**Table A Applicant’s Responses to Departmental Comments**

Project Title	TRAFFIC ENGINEERING CONSULTANCY SERVICES – RESIDENTIAL REDEVELOPMENT AT 8 KA SHUE ROAD, SAI KUNG, TSEUNG KWAN O
Figure Title	SWEPT PATH ANALYSIS OF A 11m HGV IN AND OUT OF THE L/UL BAY

dwg ref. F01

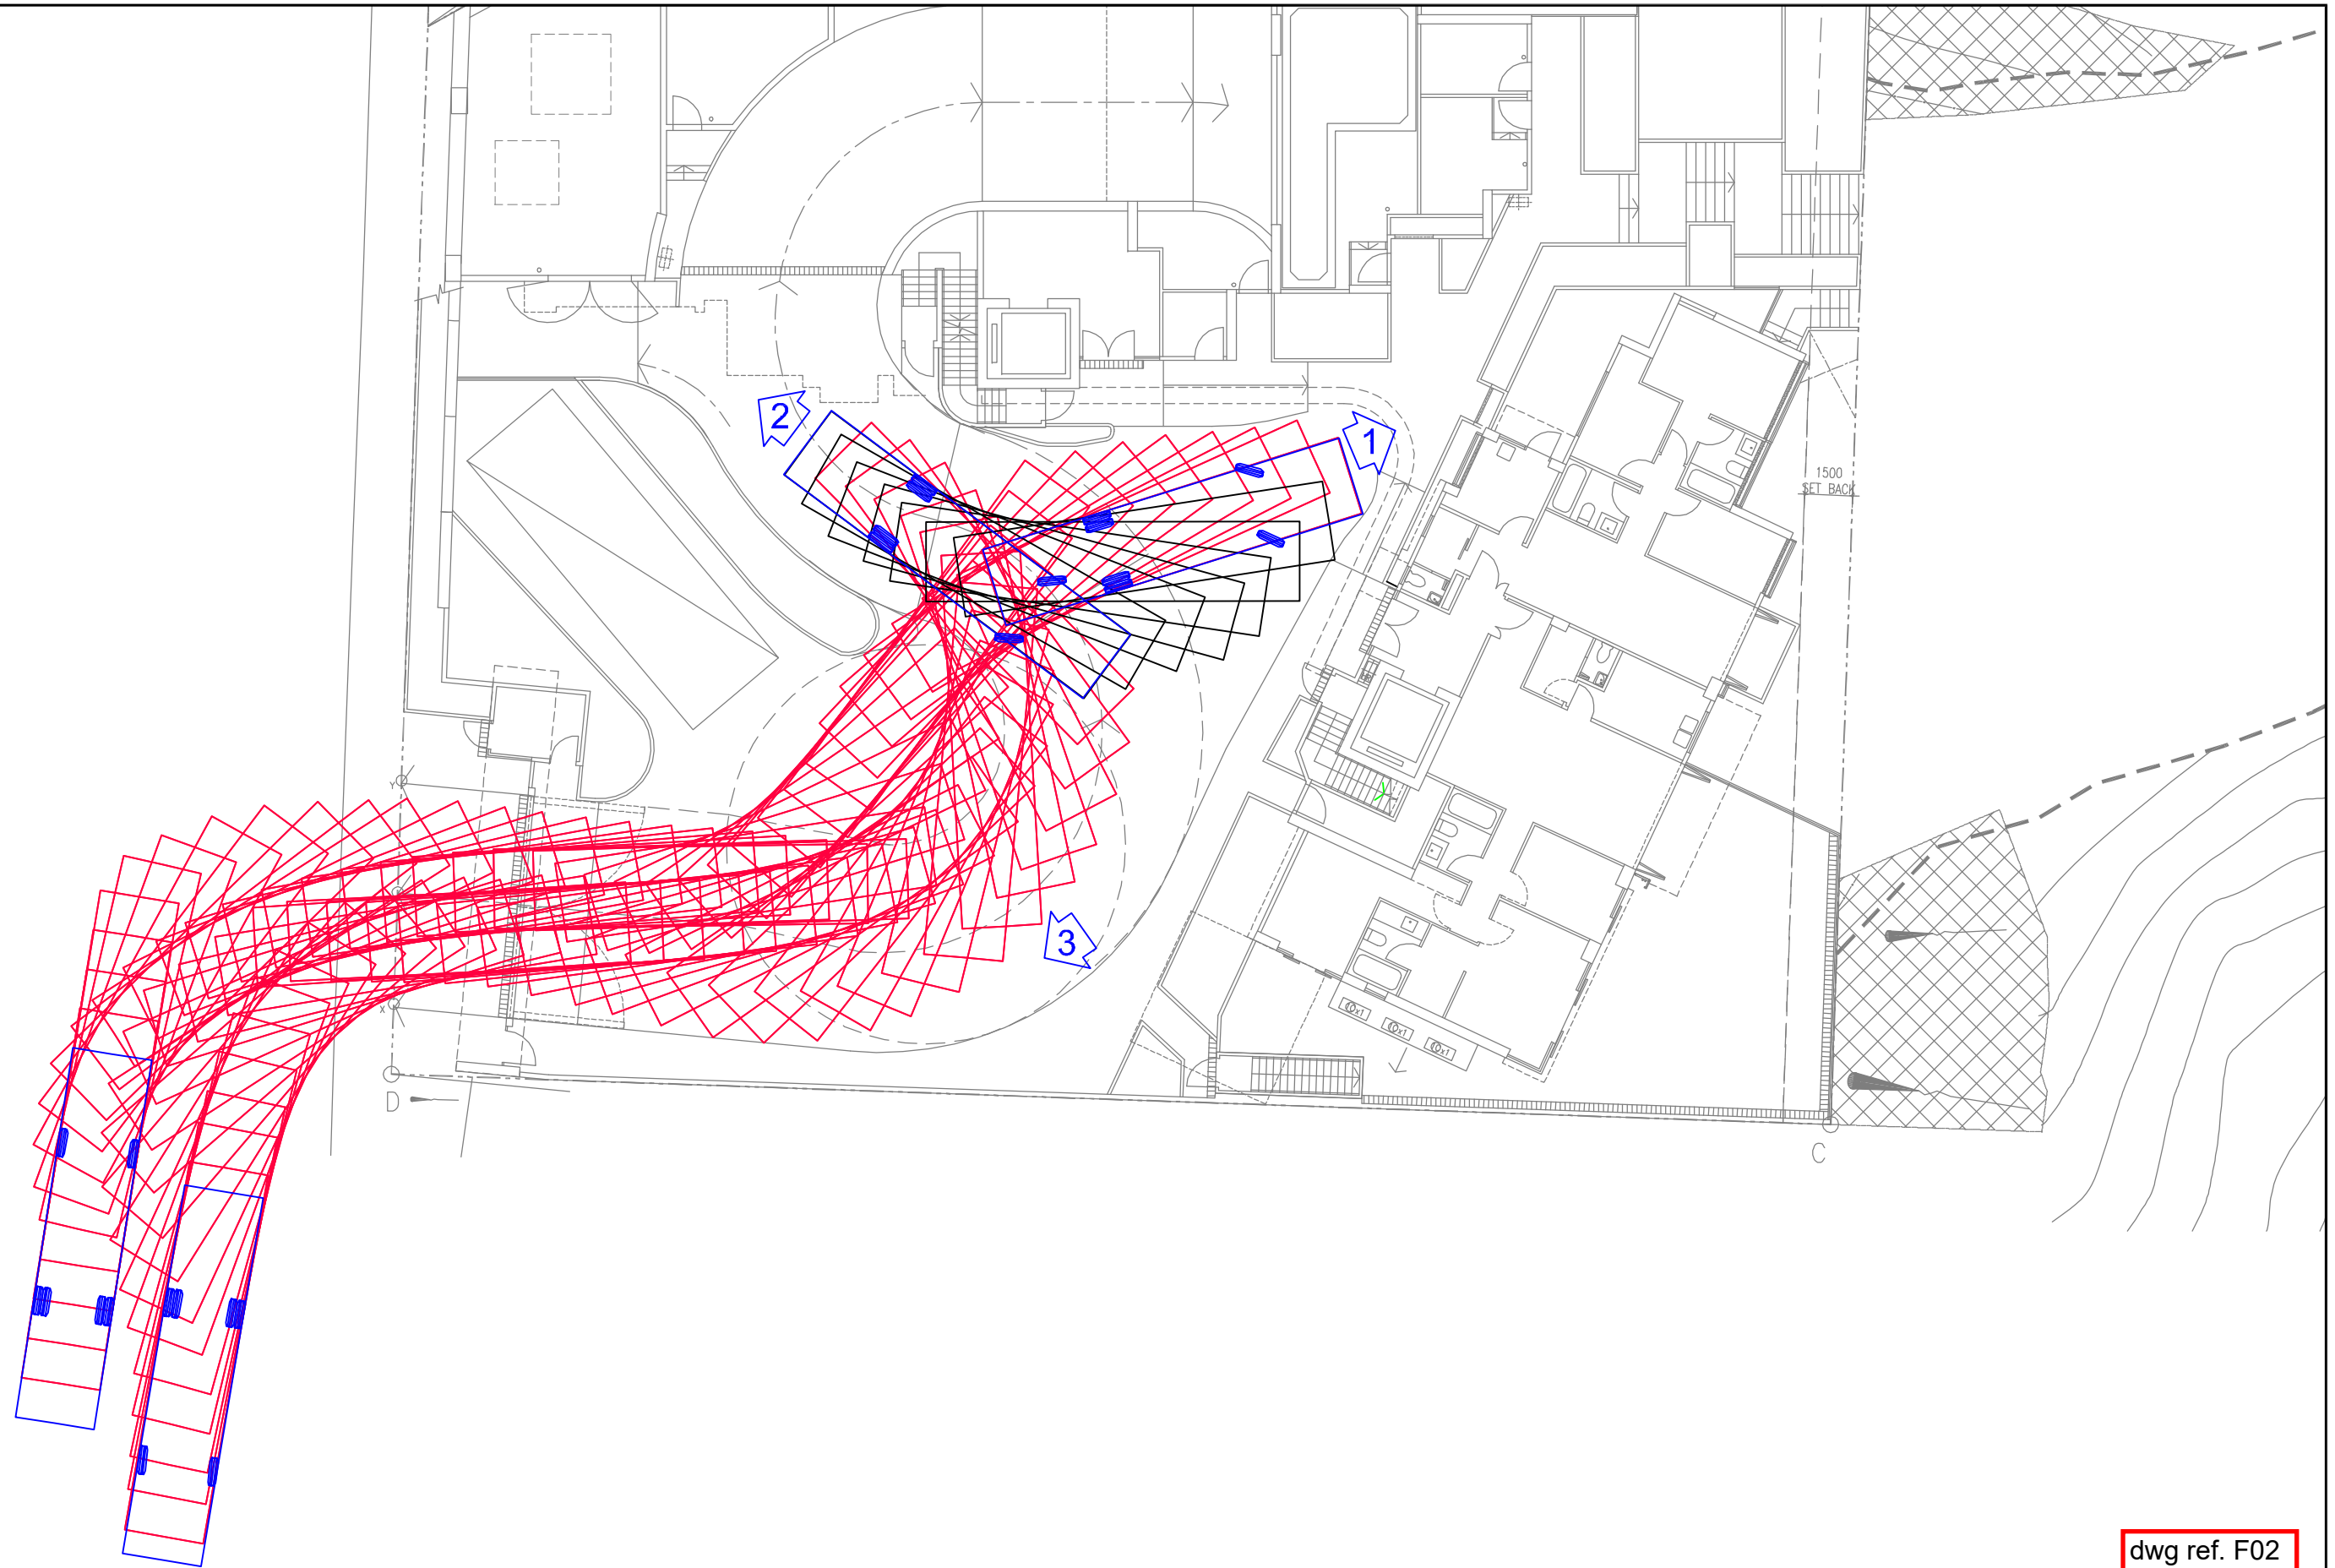
2.	Please provide the swept path analysis for the loading and unloading area.	Please refer to revised dwg. Ref. F01 and F02 attached in <b>Table A</b> .
